**Recommend Before the Panel Convener appointed under the
Fast-track Approvals Act 2024**

In the matter of Mt Welcome, Pukerua Bay

By Pukerua Property Group Limited Partnership

Appendix B - Planning Response Memorandum

Figure 8: Eastern walking track connections

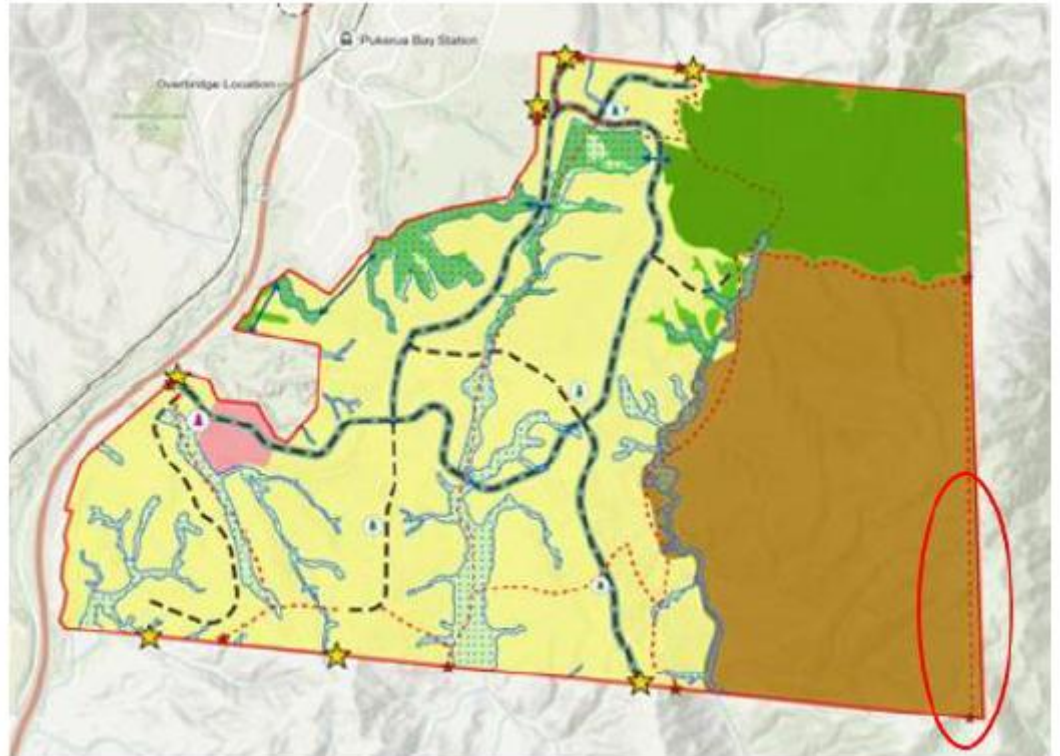
The track network is discussed, with the eastern-most track shown on the Structure Plan noted as not being provided for. The urban design review recommends it to be shown on the application plans and a condition of consent included so that it is implemented at the time the wider loop is delivered with the wider development of the NGDA. An additional off-road track connection is also recommended from the Upper Terrace as an extension of the track that terminates to the south of Road 7 as no northern connection is currently provided for in accordance with the Structure Plan.

63 I do not agree that the plans need to be amended or a condition of consent included requiring the far eastern walkway be provided in the future. The Applicant has provided an indicative location for a trail head in the MLUDS (page 31), which could feasibly be located within the reserve at the end of Road 27 in Stage 16A. As such, the development does not preclude this aspect of the Structure Plan being given effect to in the future.

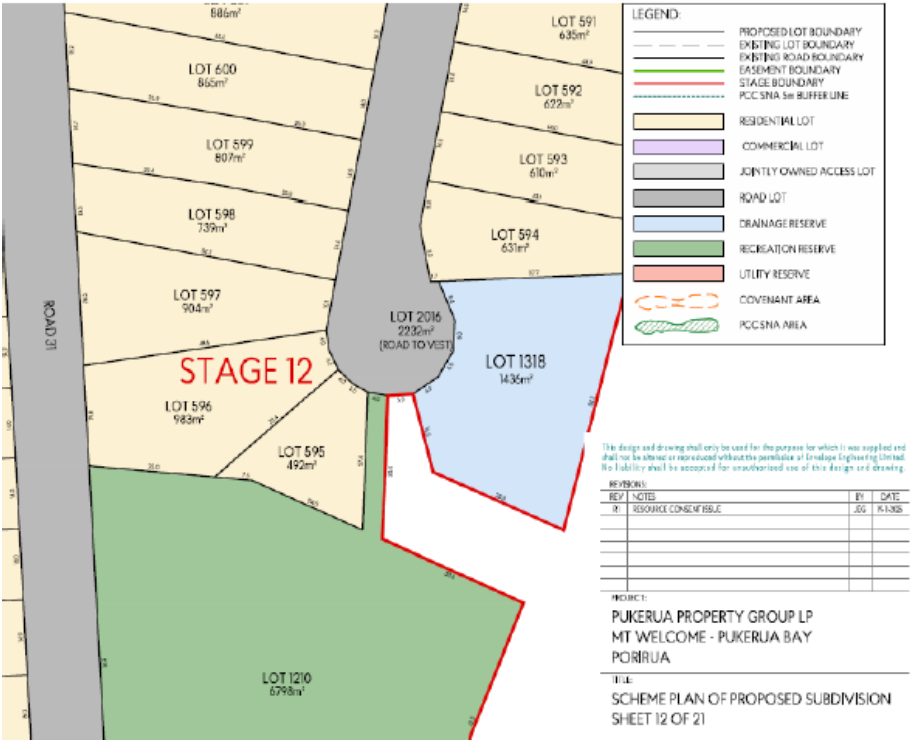
I consider that the Applicant's assessment does not account for the significant constraints created by the proposed subdivision layout on the ability to achieve the east-west roading connection shown on the Structure Plan in the future. These constraints are created in relation to both the western and the eastern connections of the future road at the termination points of both Road 21 and Road 25.

As shown in Figure 3 below, stage 15 in the scheme plan terminates at a recreation reserve. PCC has raised an issue where the proposed reserve status of this land effectively precludes a future roading connection to lot 5003 as it is very difficult to revoke recreation reserve status once gazetted. The Applicant has therefore updated

the scheme plan to relabel a portion of this area as road reserve as shown in Figure 3 below. It would be a “paper road” that could be used in the future to provide access to 5003. The Applicant proposes in the interim to construct the reserve for use for recreation until such time it is required for a future road. An updated scheme plan is provided as Appendix E.
